Access Compliance Report

Public Rights-of-Way

(Curb Ramps)

Intersection ID: 26014	Main Street: ARRINGTON MANOR PL	Cross Street: HOLLY HILL FARM RD	Location: NE
ADA ID: ED3C8927CCDA	Ramp Type: PerpDiag	Initial Pass/Fail: Fail	Overall Compliance: No
Severity Score: 25			
Codes/Mitigation Info/Possible Solution		Field Measurements/Component Compliance

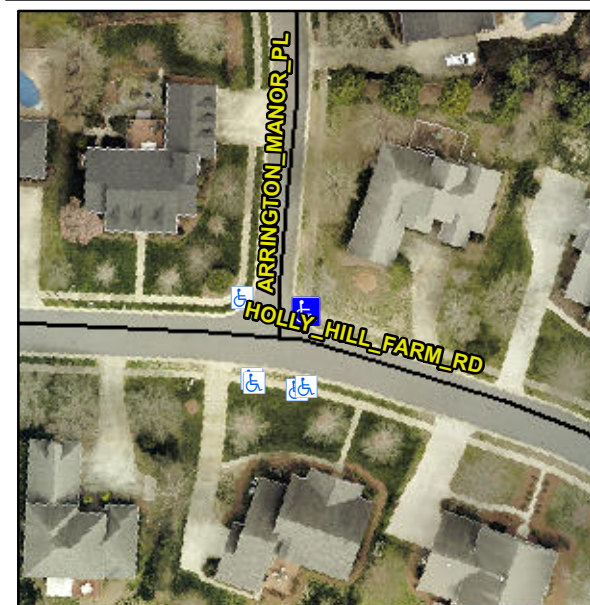
R304.5.3

Compliance	Description	Data	Compliance	Description	Data
N/A	Ramp Length (in)	50.0	Yes	Ramp Slope (%)	7.1
Yes	Ramp Width (in)	48.0	No	Ramp XSlope (%)	7.0
N/A	Flare Type LT	N/A	N/A	Flare Type RT	N/A
N/A	Flare Slope LT (%)	N/A	N/A	Flare Slope RT (%)	N/A
N/A	Flare Traversable LT?	N/A	N/A	Flare Traversable RT?	N/A
N/A	Landing Length (in)	N/A	N/A	DWS Provided?	N/A
N/A	Landing Width (in)	N/A	N/A	DWS Contrast?	N/A
N/A	Landing Slope (%)	N/A	N/A	DWS Length (in)	N/A
N/A	Landing X Slope (%)	N/A	N/A	DWS Full Width?	N/A
N/A	Landing Curb? (Y/N)	N/A	N/A	DWS Offset (in)	N/A
N/A	Shared Landing?	N/A			
N/A	Gutter Ponding?	N/A	N/A	Gutter Slope (%)	N/A
N/A	Gutter Lip Ht (in)	N/A	N/A	Gutter X Slope (%)	N/A
N/A	Painted X Walk1?	No	N/A	Painted X Walk2?	No
	X Walk 1 Direction	To NW		X Walk 2 Direction	To SW
N/A	X Walk 1 Width (in)	N/A	N/A	X Walk 2 Width (in)	N/A
	X Walk 1 Slope (%)	5.2		X Walk 2 Slope (%)	4.9
	X Walk 1 X Slope (%)	4.0		X Walk 2 X Slope (%)	7.3

Remove & Replace Curb Ramp With Two New Directional Ramps or Equivalent.
